Subject: Bangor Savings Bank

Windham Branch/Office Parking Expansion Response to Staff Review Comments

servericfsBangor Savings BankiNorth Windham - Abby Road Parking/AcadiPlansIDETAILS.dwg. 9/30/2021 5.09:58 PM, bwb

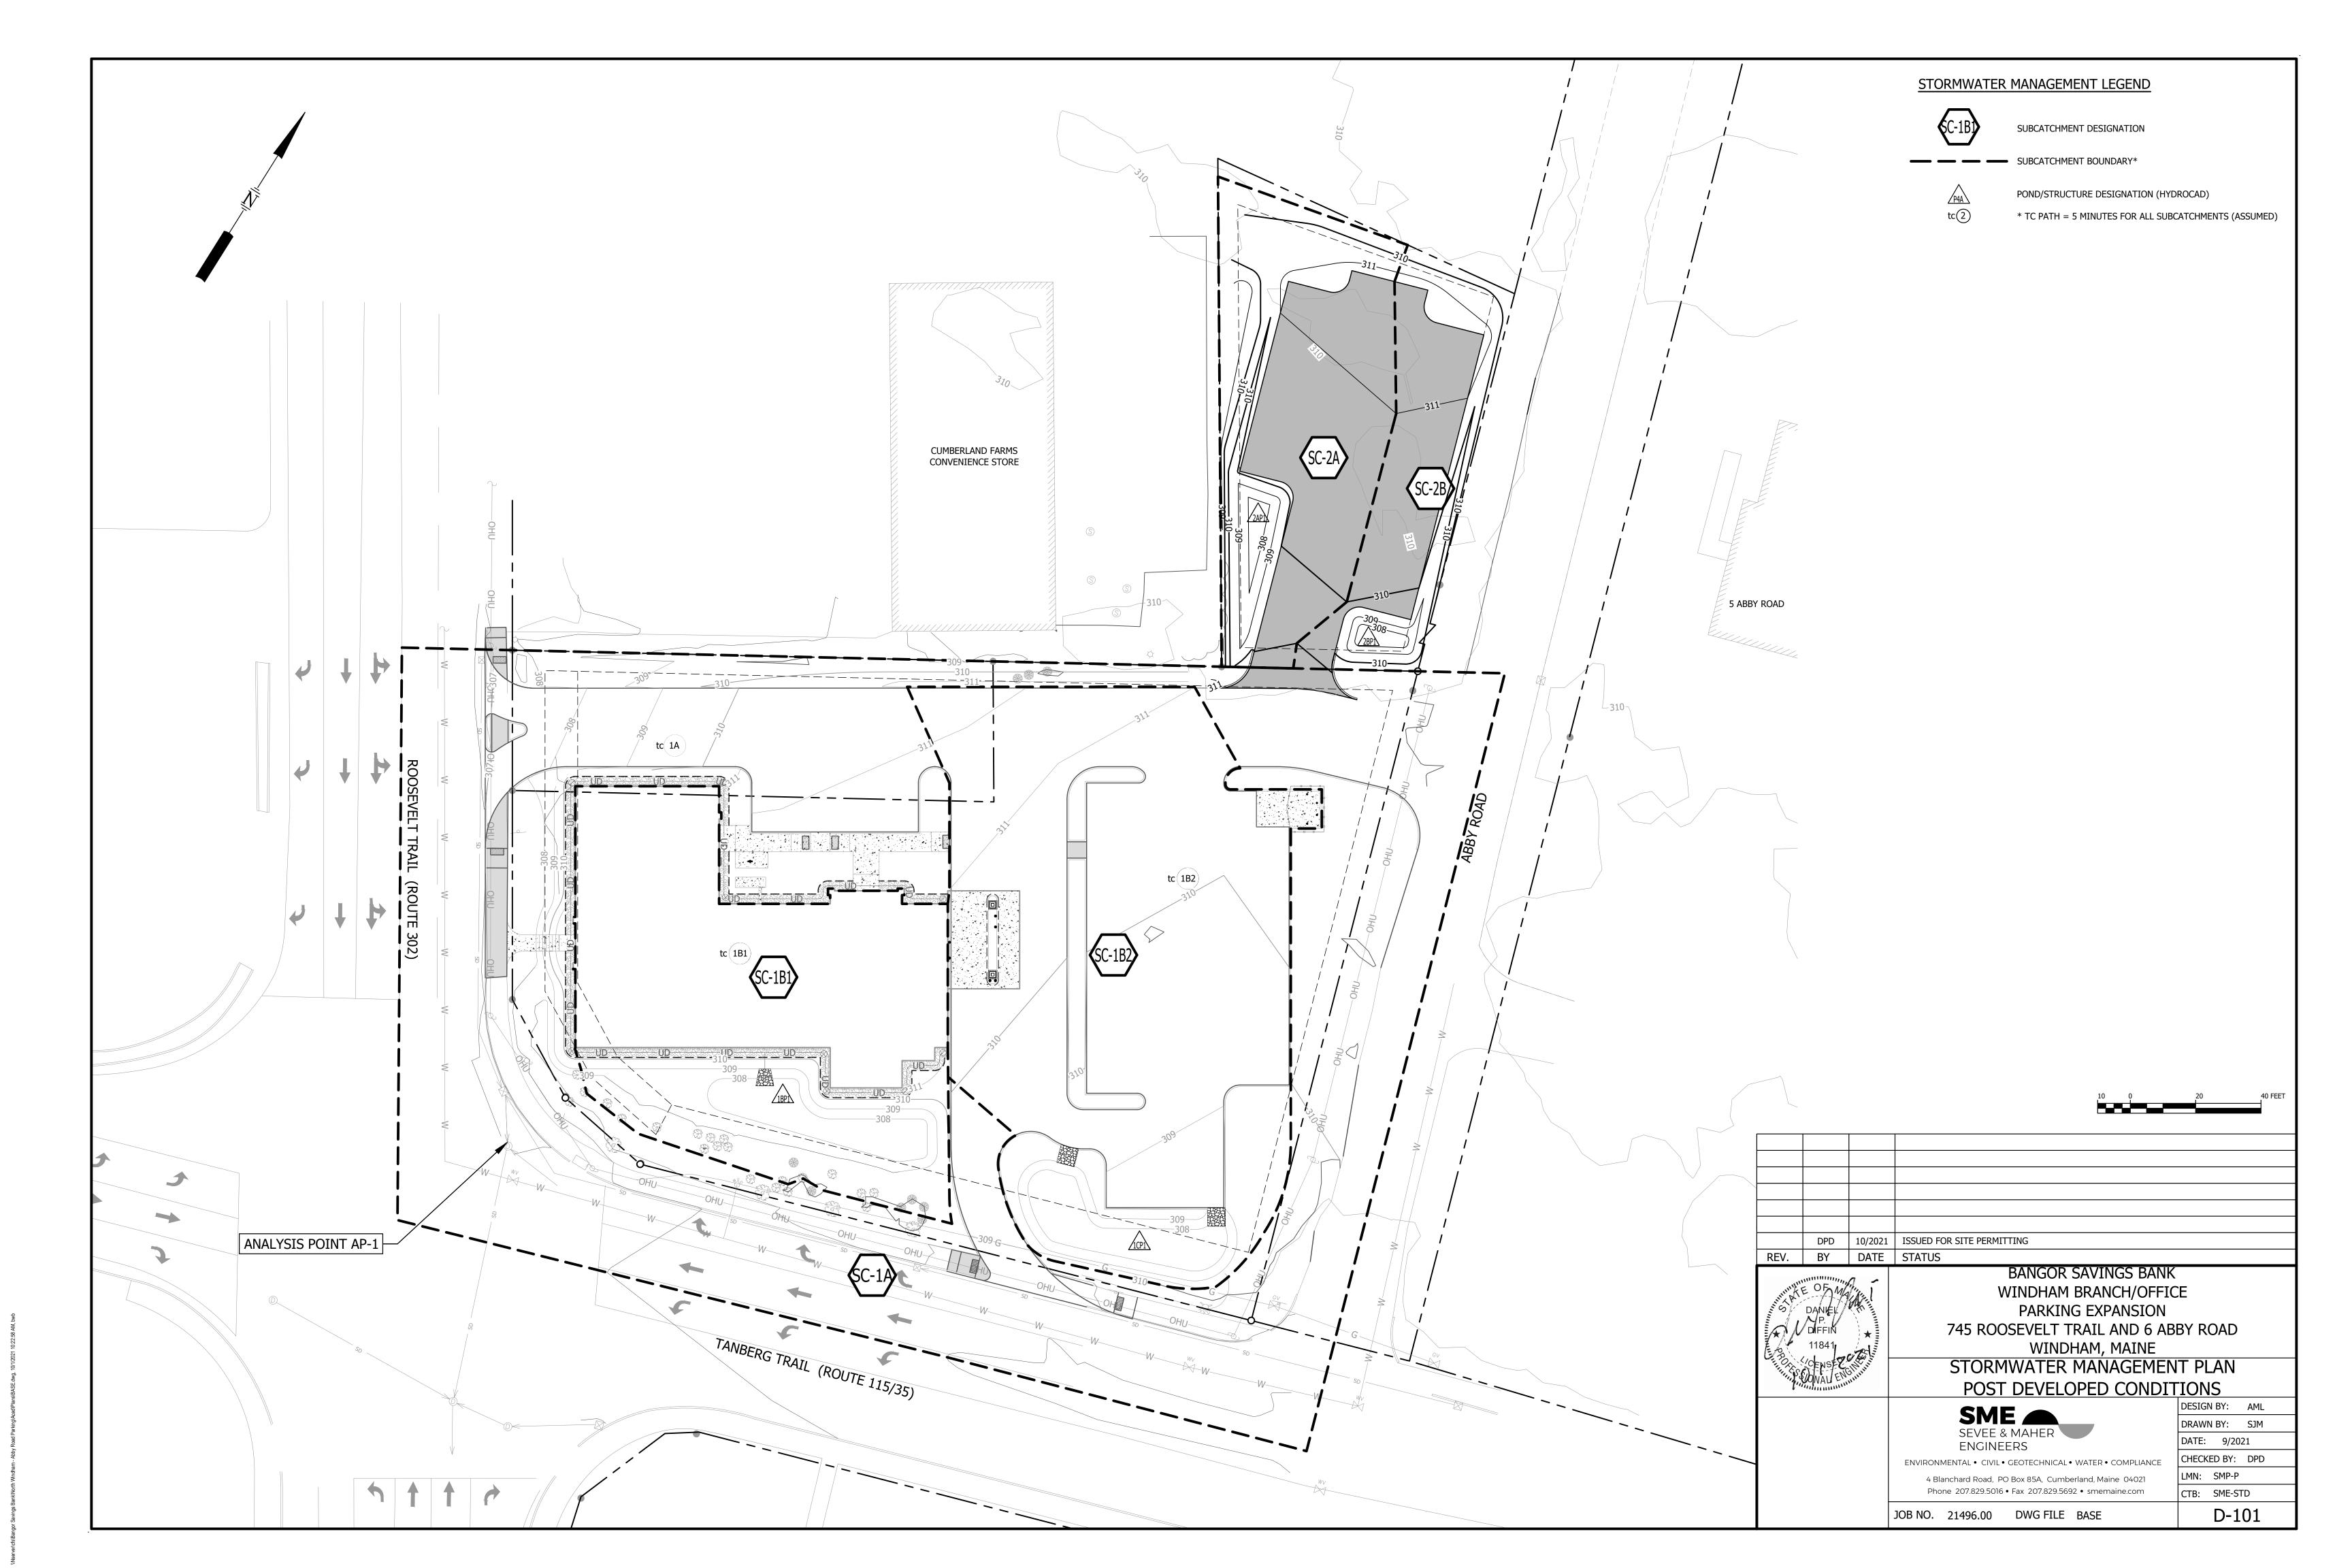
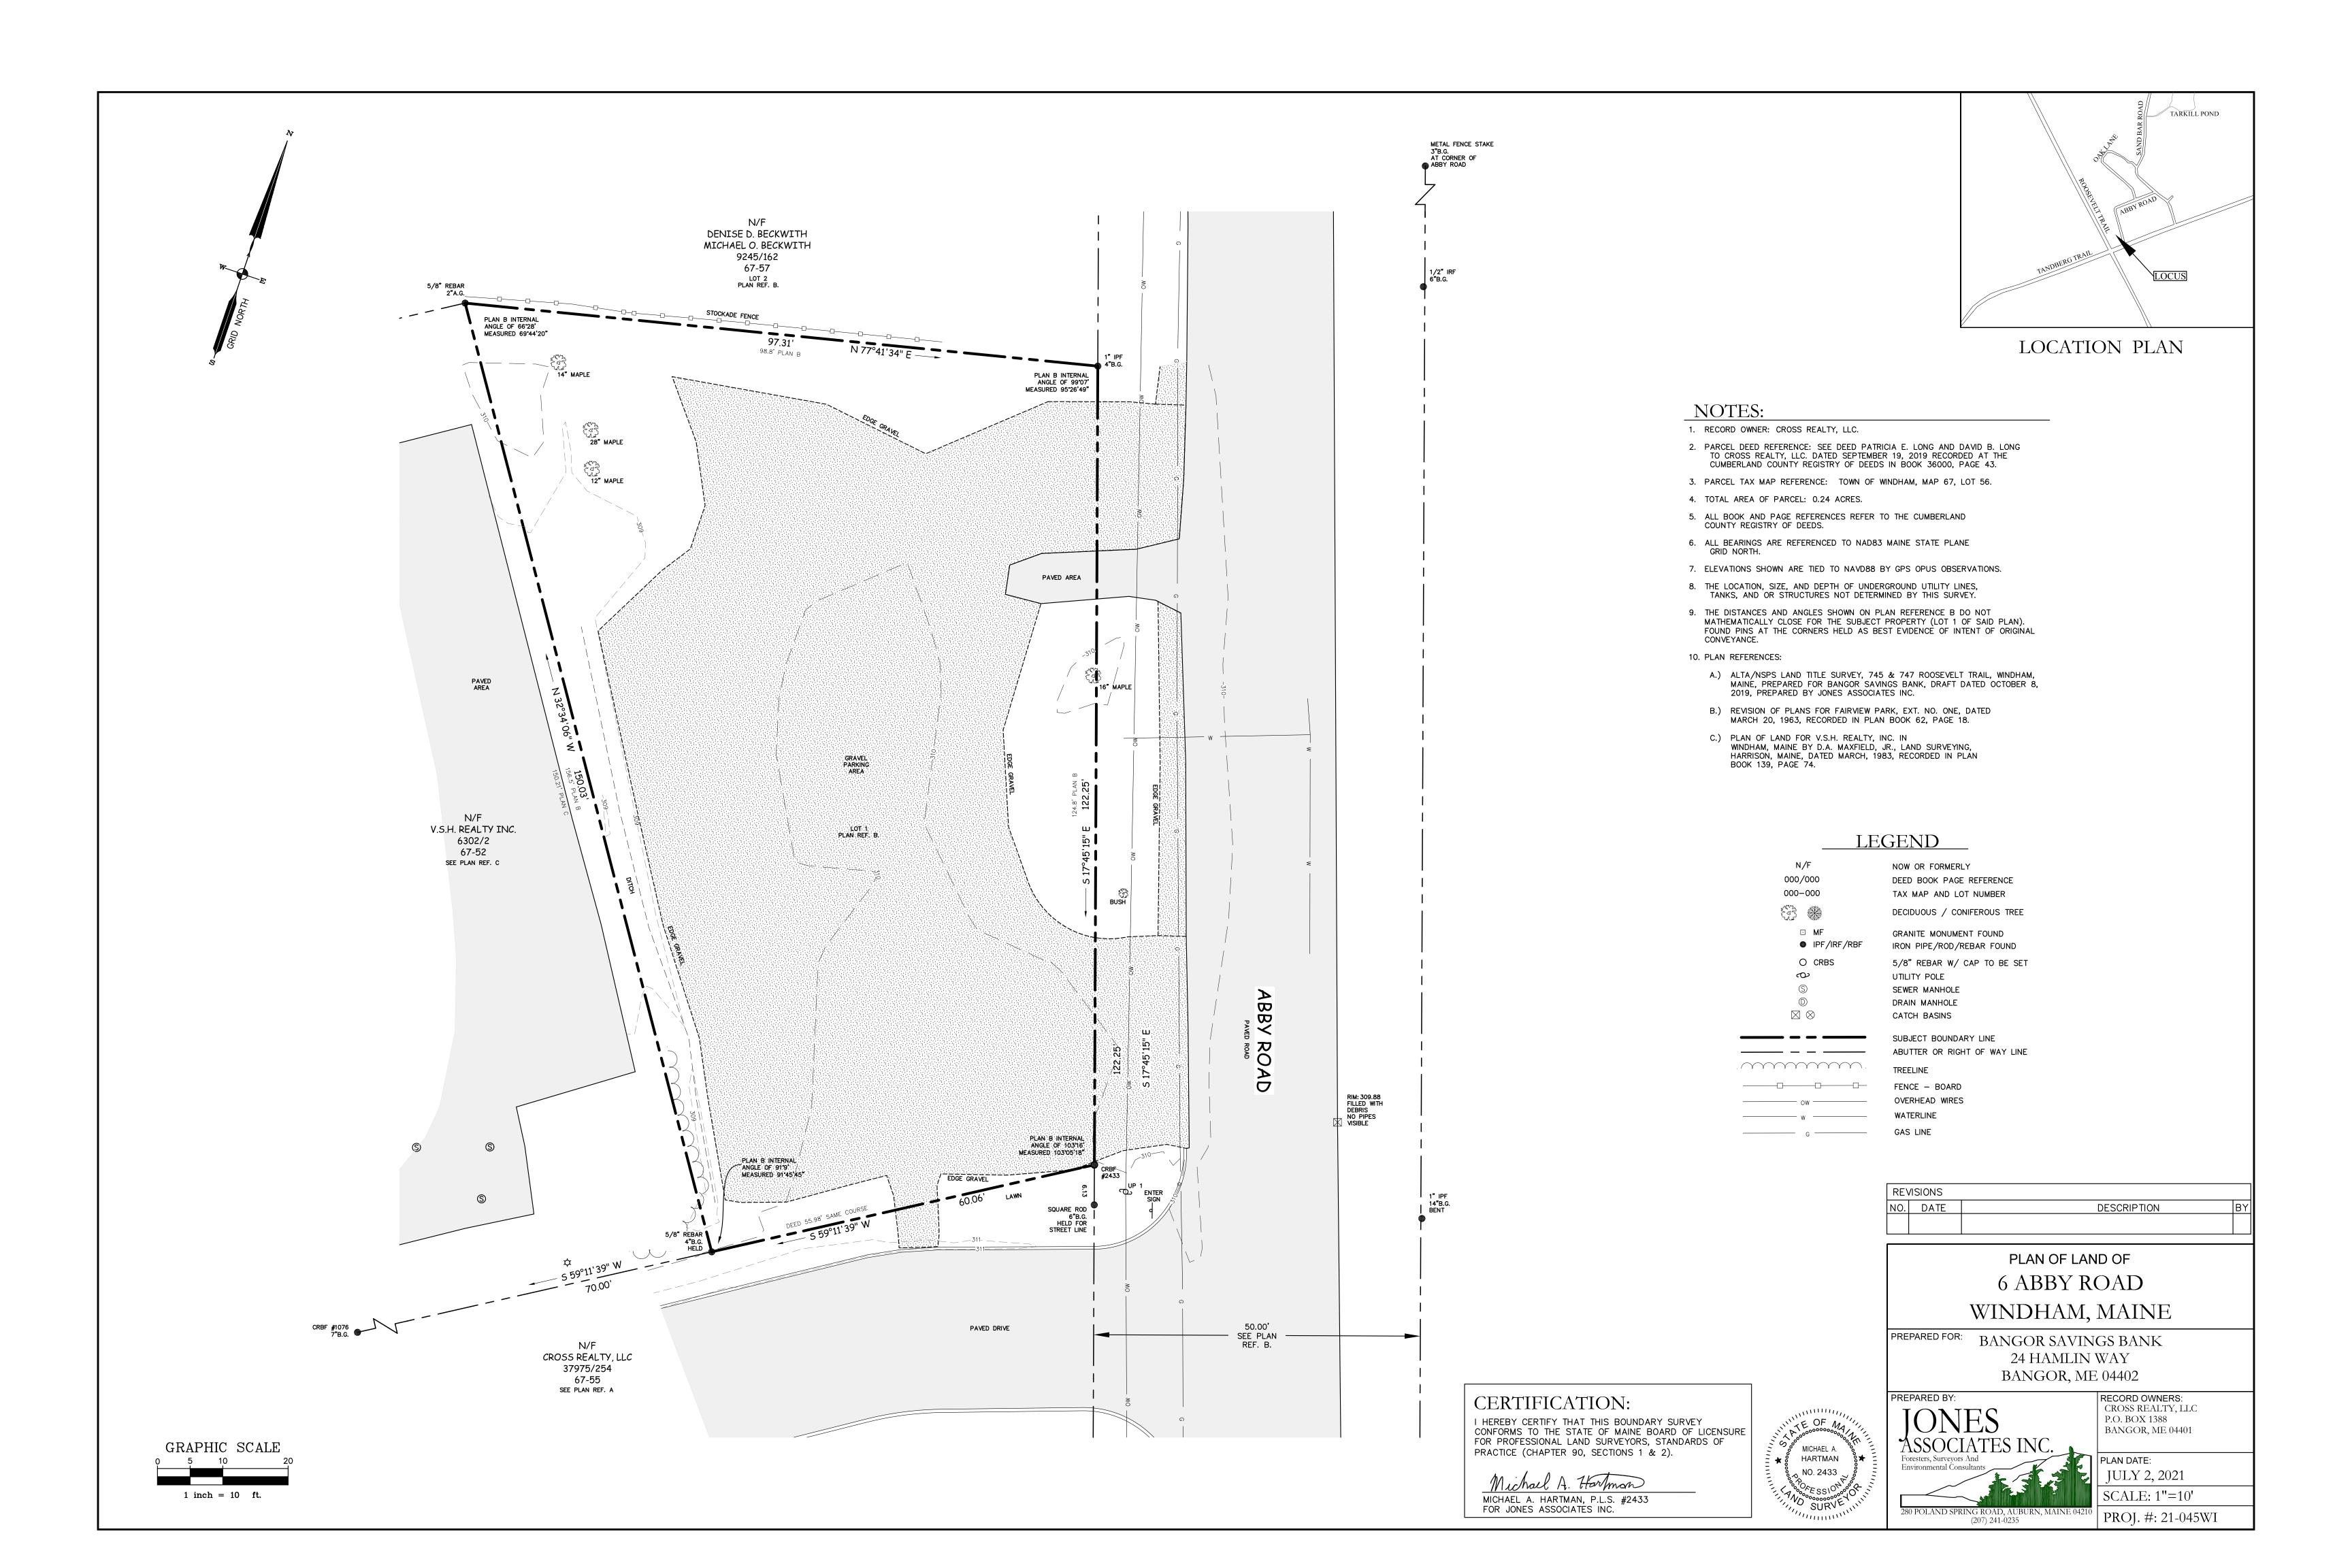
12. The proposed grading is 1H:1V or steeper along the westerly property line of the parking lot parcel. How will this be permanently stabilized?

<u>SME Response</u>: Steep slopes will be stabilized with riprap underlain by geotextile fabric. Locations of proposed riprap slope protection are identified on sheet C-105 and detailed on sheet C-300. The updated plans are attached to this letter.
